SERVICE BULLETIN

PURPOSE : INFORMATION	ISSUE NO. : MSB-08E13-002B	DATE : 2008-03-20
SUBJECT : CAUTIONARY INSTRUCTION FOR ENGINE-ECU REMOVAL AND INSTALLATION	<div> <div><MODEL></div> <div>(EUR/RUSSIA)</div> <div>LANCER</div> <div>(GS41)(CY0A),</div> <div>OUTLANDER</div> <div>(GS45X)(CW0W)</div> </div> <div> <div><M/Y></div> <div>07-</div> </div>	
GROUP : FUEL

A cautionary instruction for the engine-ECU removal and installation is modified. This Service Bulletin contains the new instruction.

AC606213AB

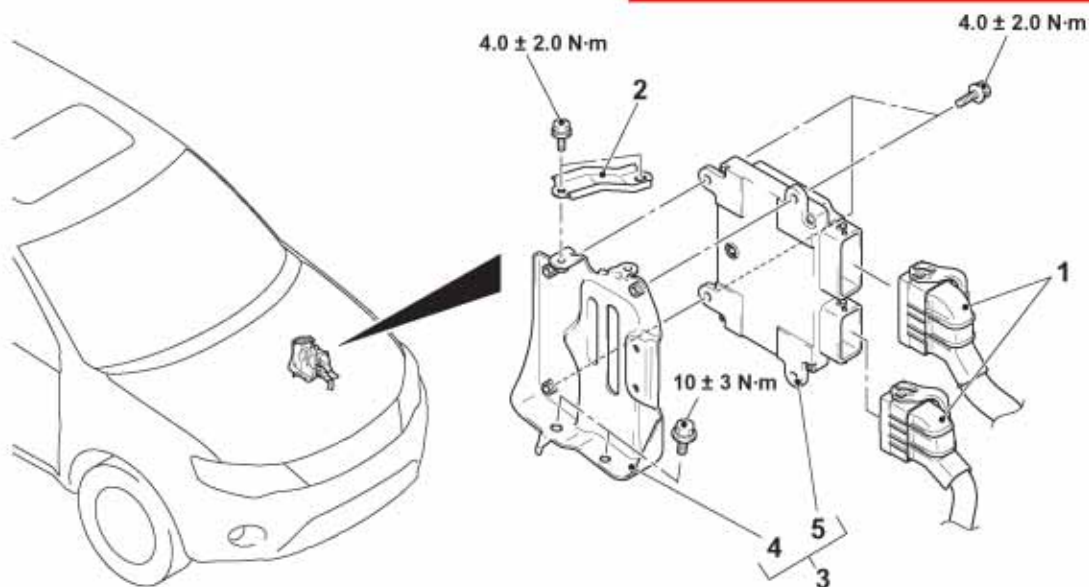
- After the replacement of the engine-ECU, register a key code using M.U.T.-III [Refer to GROUP 00 – Precautions before Service, How to Perform Chassis Number (Chassis No.) Writing]. <Old>

- For replacement of the engine-ECU, use an engine-ECU for which the vehicle identification number entry and coding are completed. If diagnosis code No. P0630 chassis number not programmed or No. P1676 variant coding system is set in the engine-ECU, replace it with an engine-ECU to which the same vehicle identification number has been entered and the same coding has been made as for the relevant vehicle.

When the engine-ECU is replaced, save the chassis number and perform the variant coding.

AC613515AB

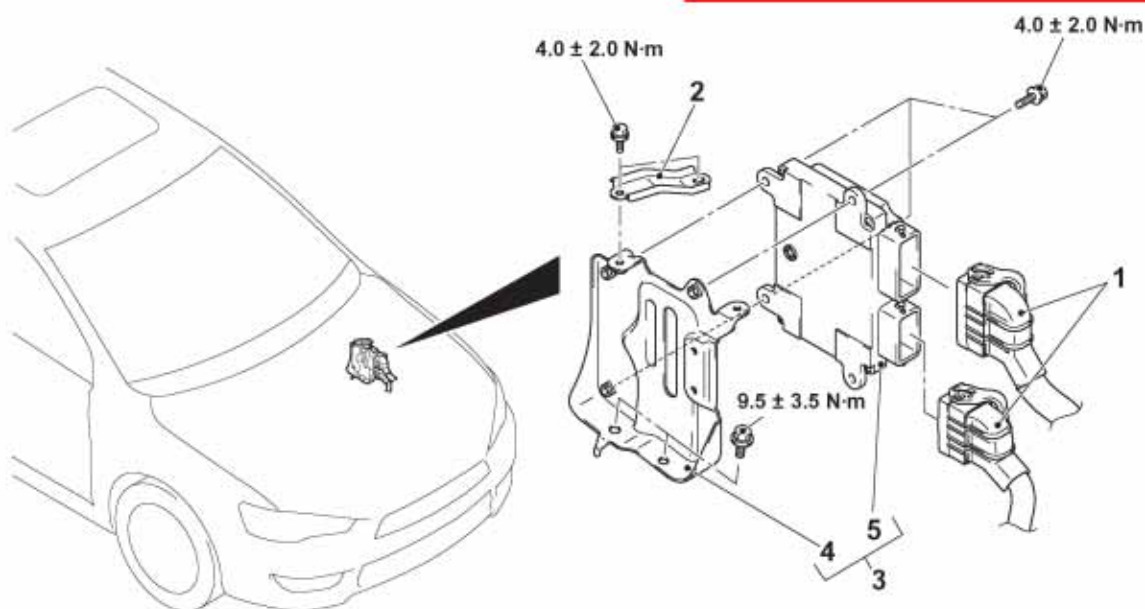
- After the replacement of the engine-ECU, register a key code using M.U.T.-III (Refer to GROUP 00 – Precautions before Service, How to Perform Chassis Number Writing). <Old>

- For replacement of the engine-ECU, use an engine-ECU for which the vehicle identification number entry and coding are completed. If diagnosis code No. P0630 chassis number not programmed or No. P1676 variant coding system is set in the engine-ECU, replace it with an engine-ECU to which the same vehicle identification number has been entered and the same coding has been made as for the relevant vehicle.

When the engine-ECU is replaced, save the chassis number and perform the variant coding.
